SB, Back Pack Blower impeller rework, EBZ7500, EBZ7500RH, EBZ8500, EBZ8500RH, 2015-11

This SB replaces B1500001.

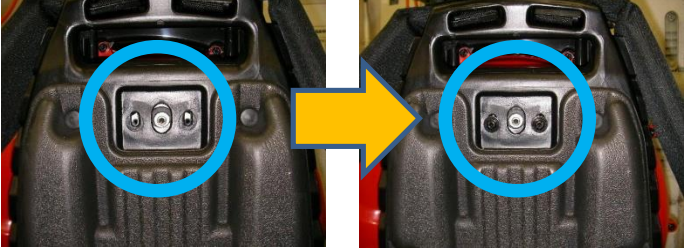
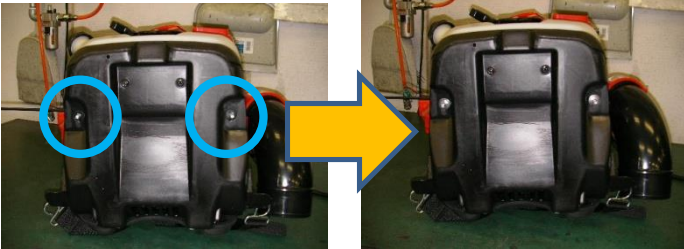
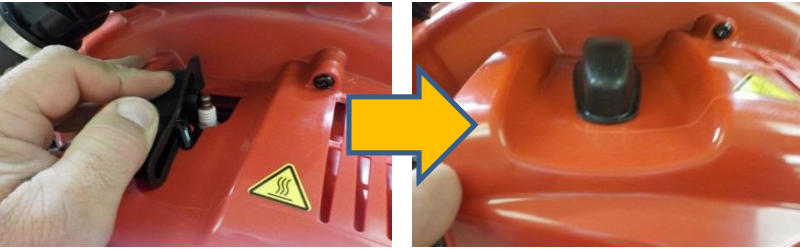
Process	Content
9	Exchange the equipped fan to the new fan.  576 56 15-01 → 589 26 61-01
10	Secure four screws for the fan.  Tightening torque → 12Nm
11	If needed, to chase two female threads on the upper damper and blow out. 
12	Secure twelve screws for the volute cover.  Tightening torque for ten screws → 3.5Nm Tightening torque for two screws around elbow → 1.0Nm
